Woolworths Regional Distribution Centre

11 Warren Road, Warnervale
NSW 2259

Access Review – DA 3 (Final)

24 March 2022

PROPOSED SITE PLAN
 SCALE: 1 : 1000

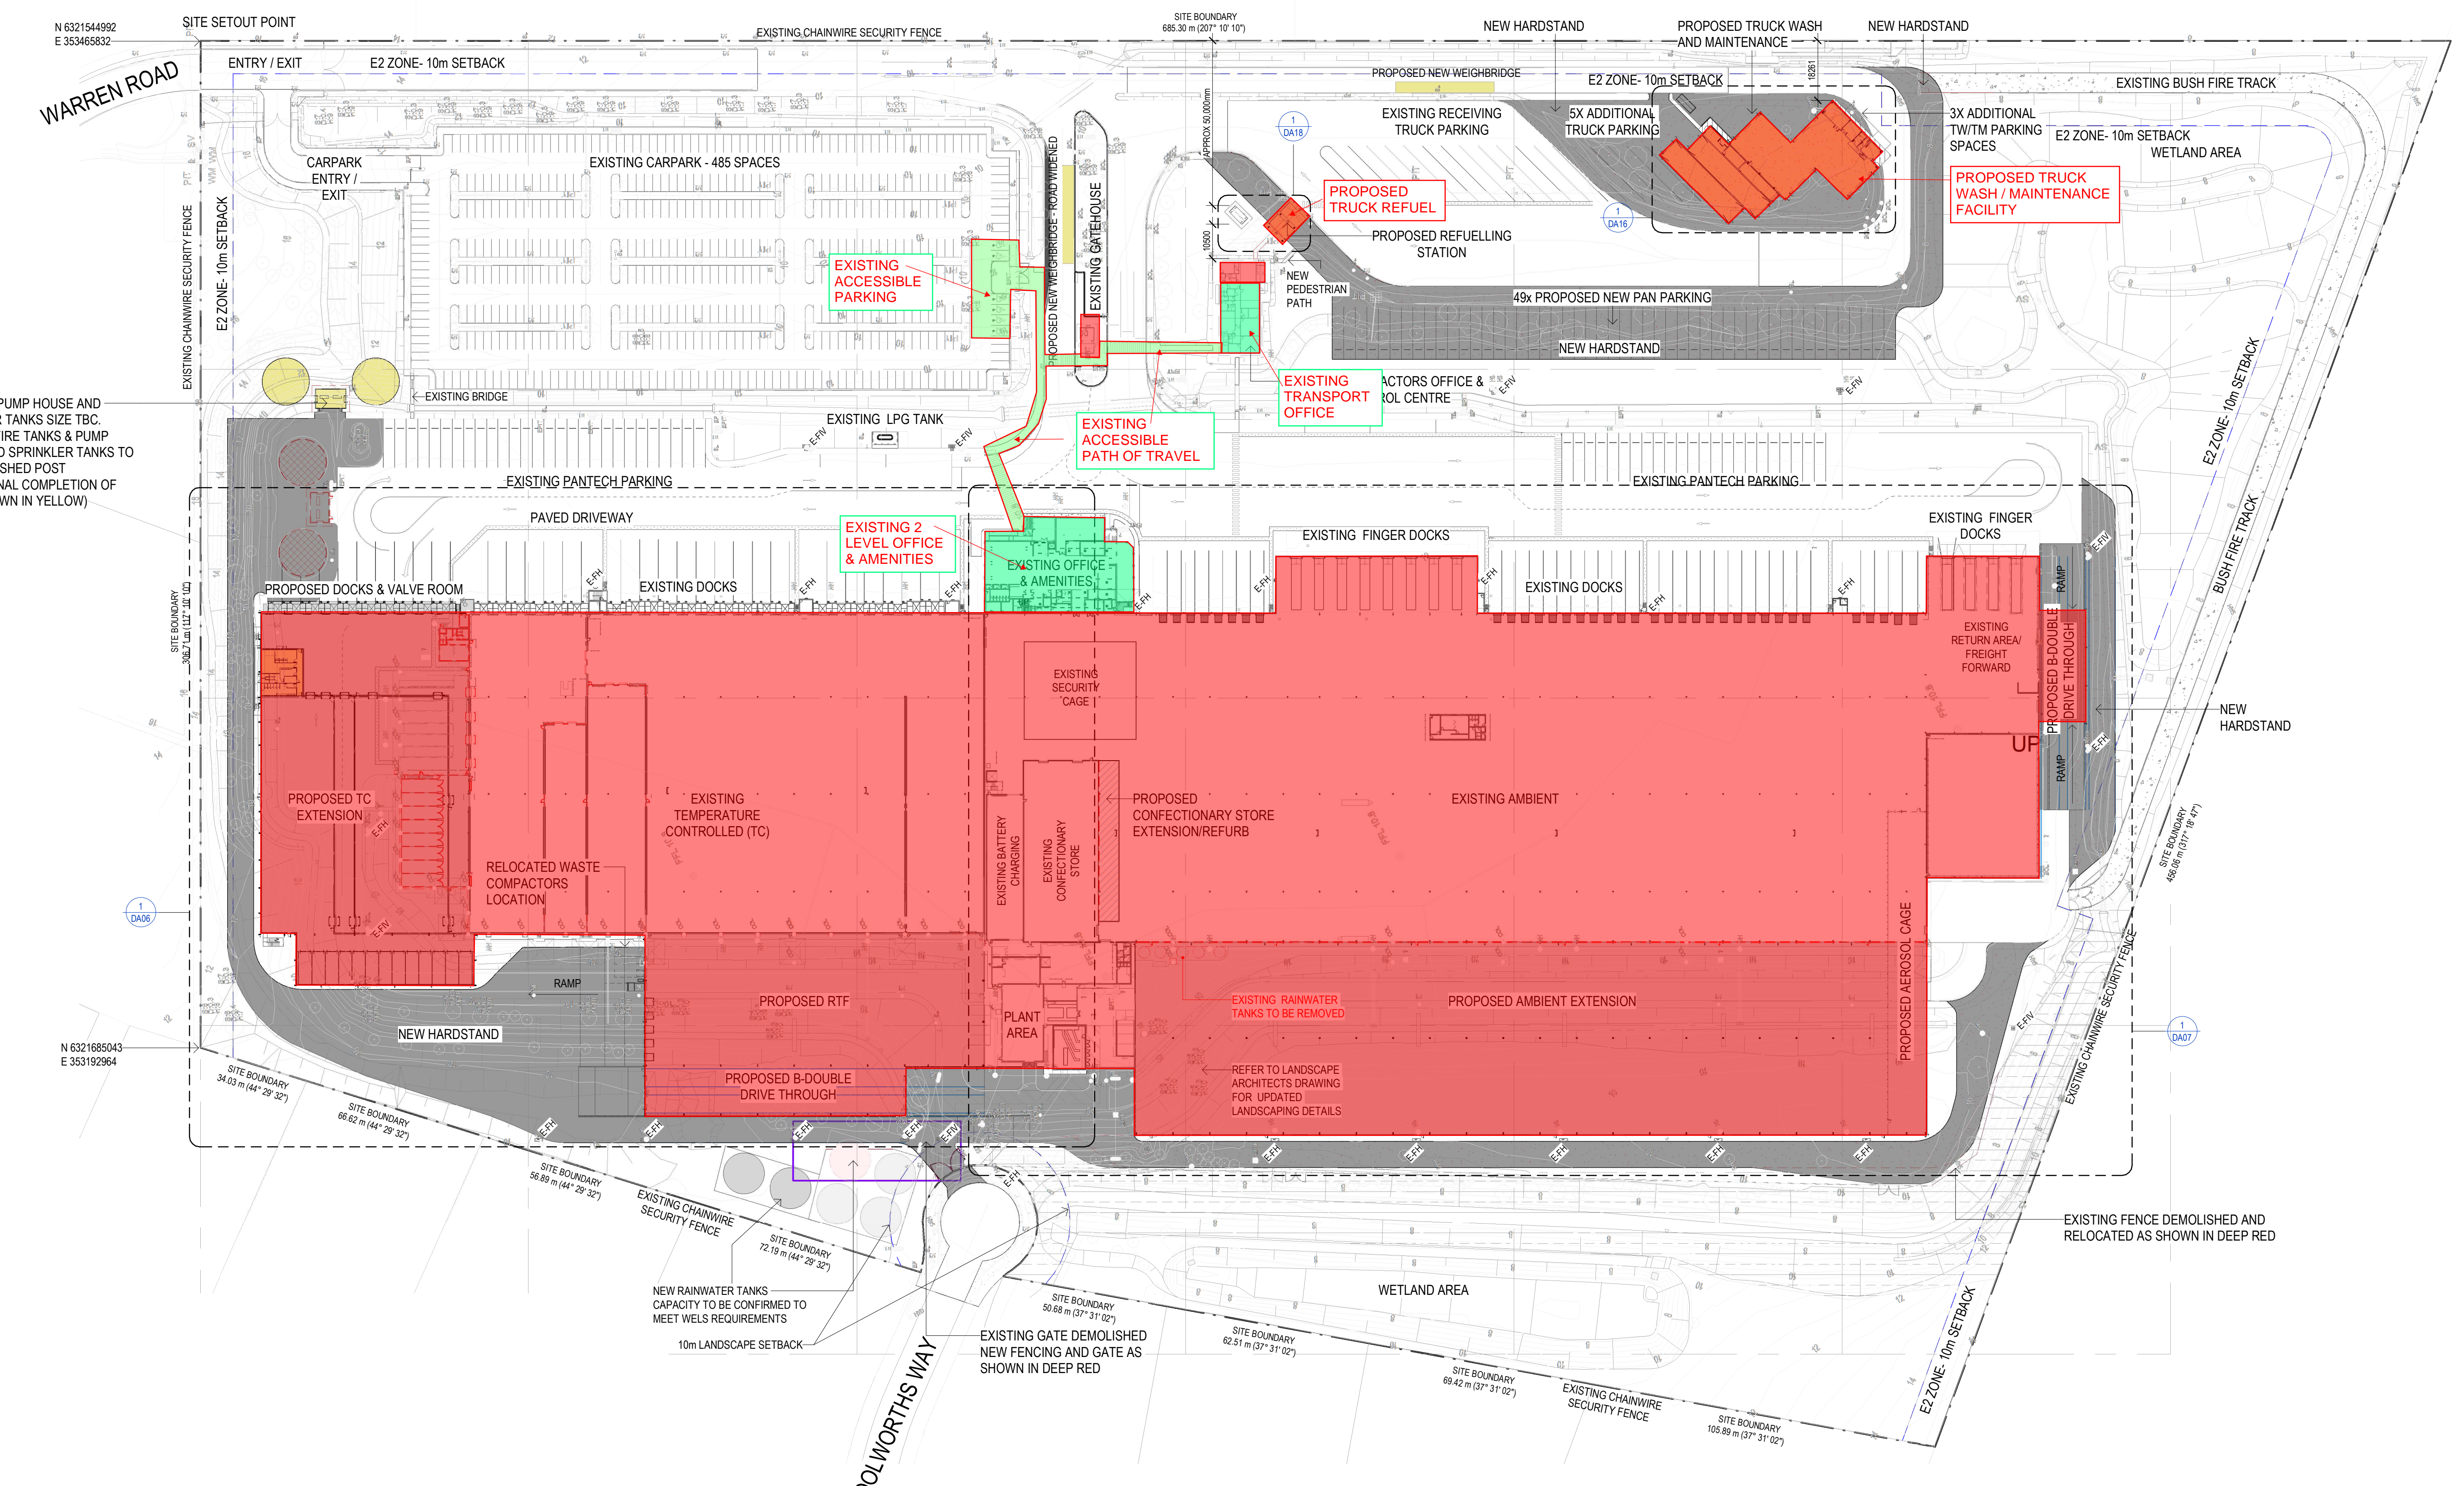
Areas not required to be accessible.
 BCA D3.4 Exemption is applicable for areas that poses the health and safety risks for persons with disability, or where access is inappropriate because of the particular purpose and use of the area.
 Due to the particular use of these areas being storage and distribution, and the health and safety risks it poses for persons with disability, it is noted access is limited to the green zone and the red zones can be D3.4 exempt.
 Consult PCA also.

TITLE: MAIN OFFICE & AMENITIES
FLOOR PLAN - LEVEL 1

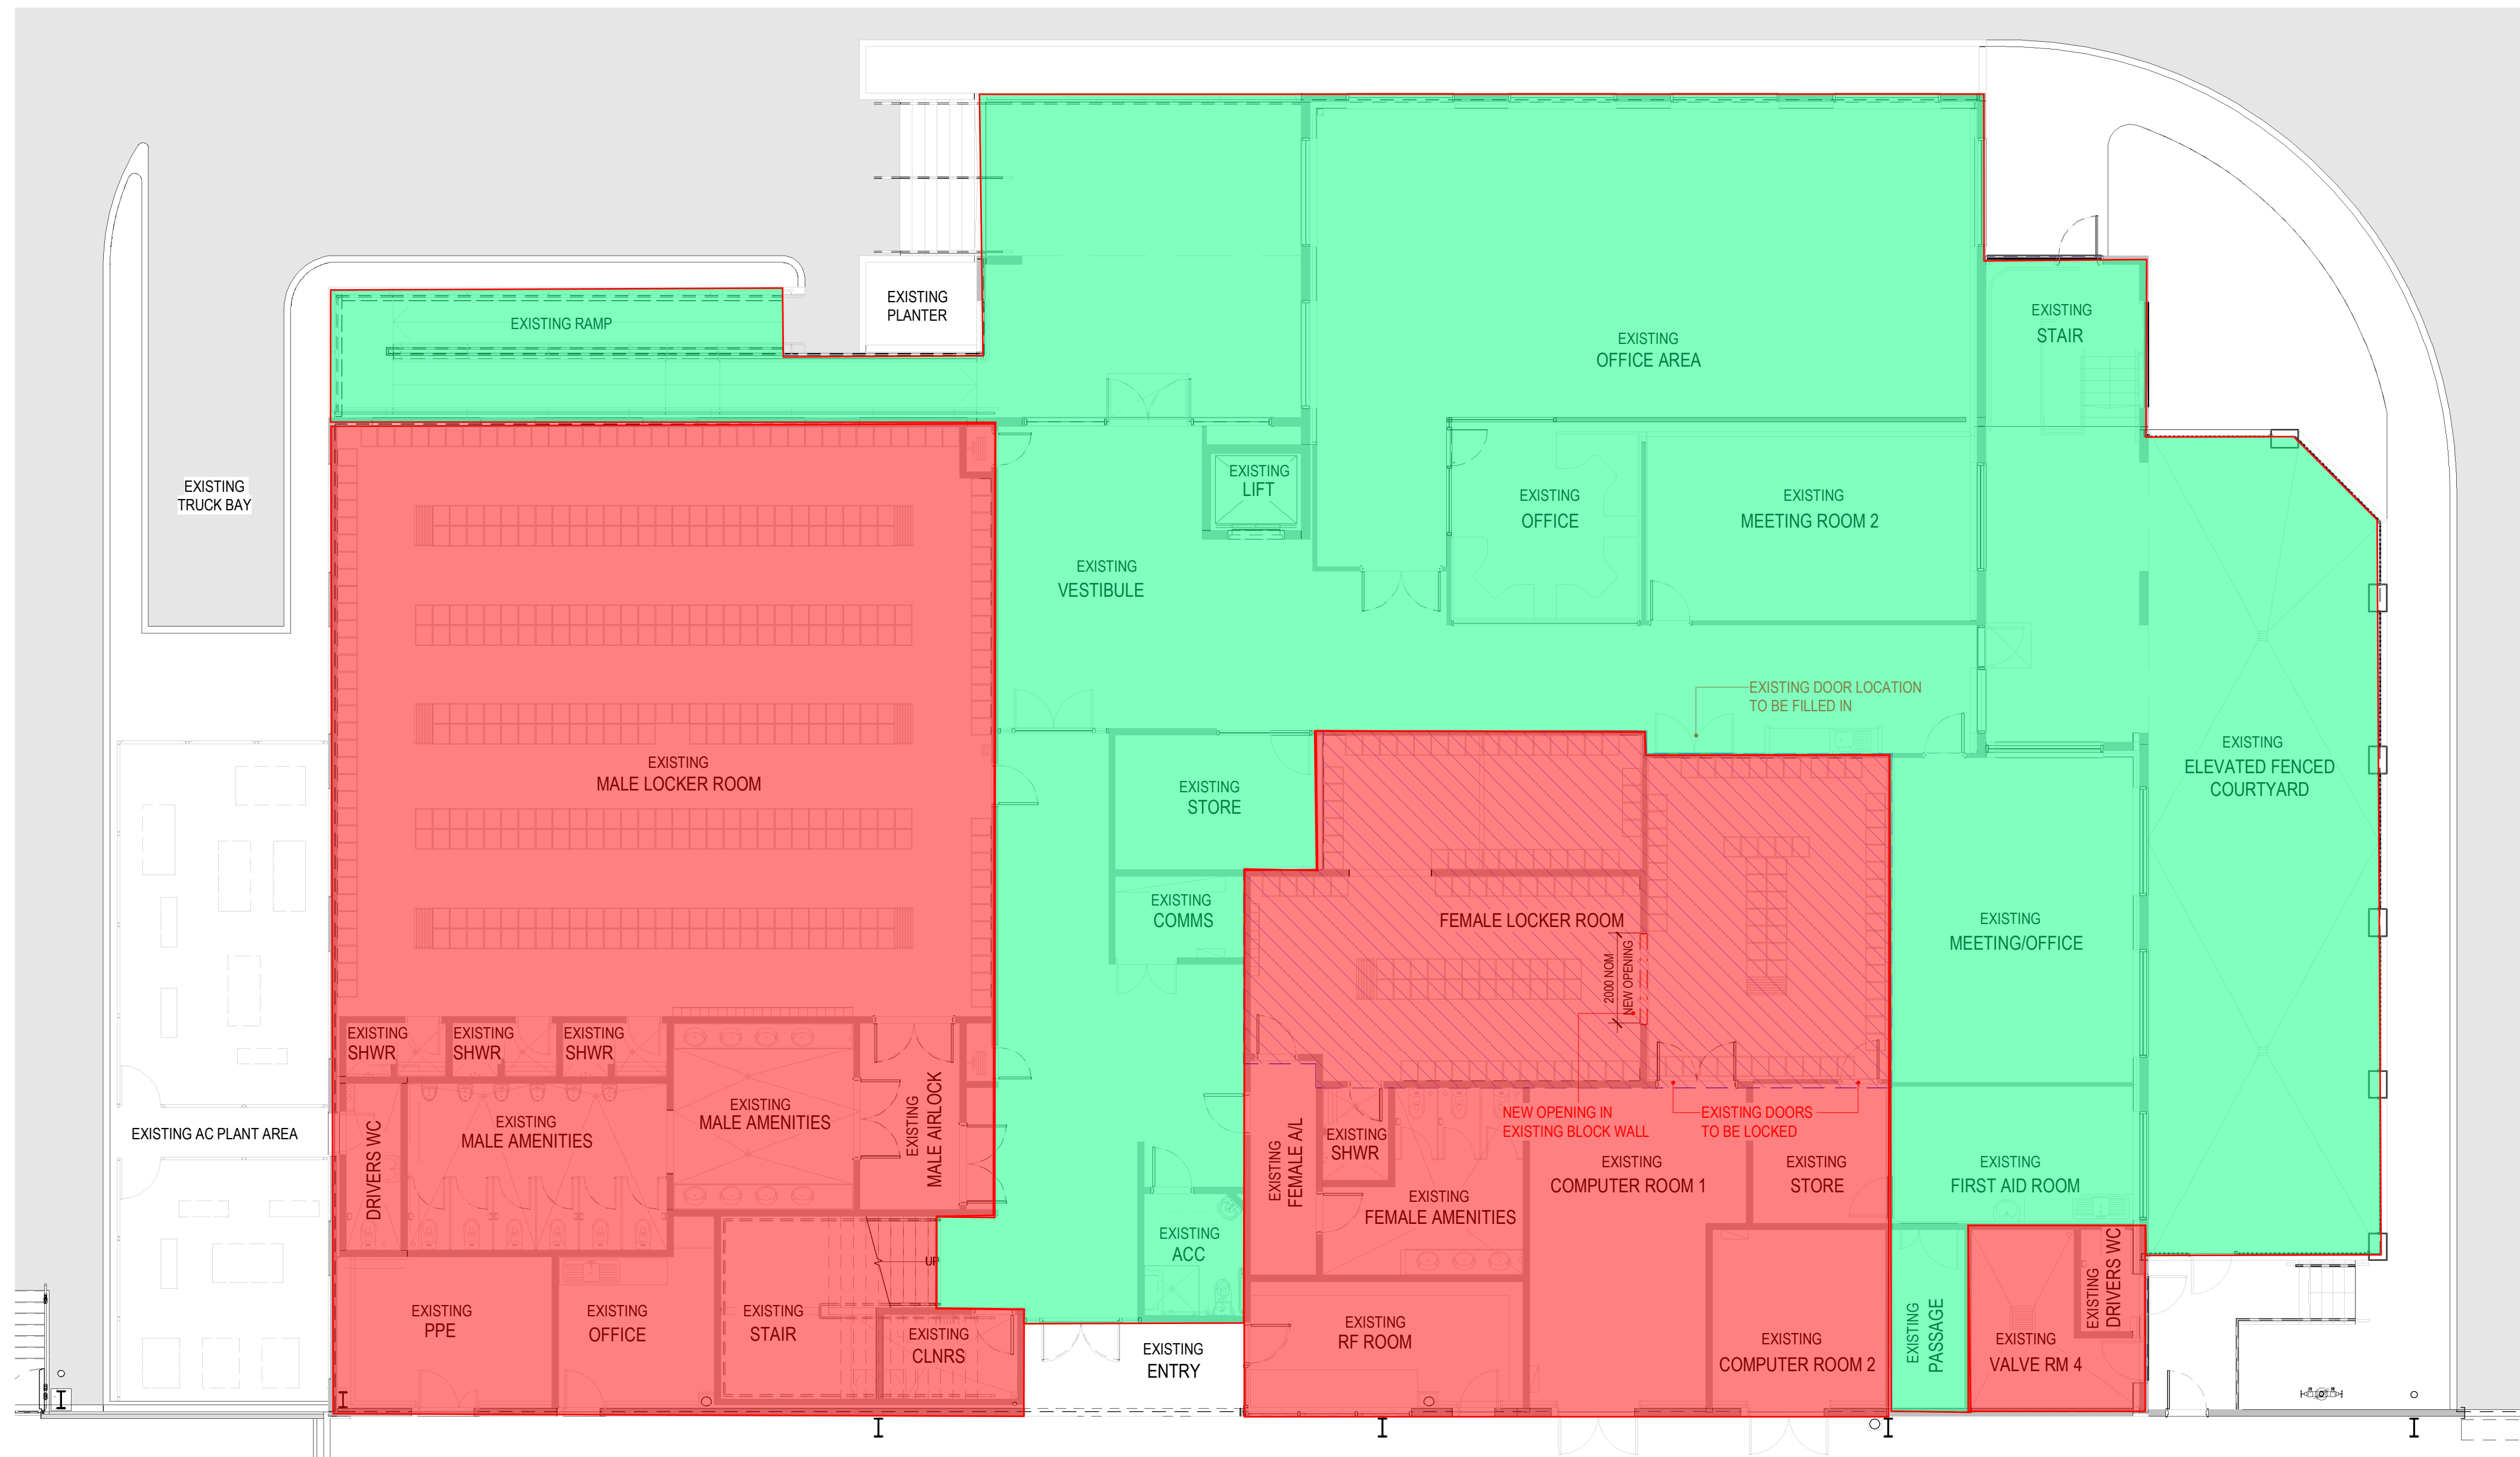
- fully accessible areas for staff visitors would need to be escorted in these areas
- non-accessible - unsafe work environment / no safe paths of travel

Areas not required to be accessible.

BCA D3.4 Exemption is applicable for areas that poses the health and safety risks for persons with disability, or where access is inappropriate because of the particular purpose and use of the area.

Due to the particular use of these areas being storage and distribution, and the health and safety risks it poses for persons with disability, it is noted access is limited to the green zone and the red zones can be D3.4 exempt.

Consult PCA also.
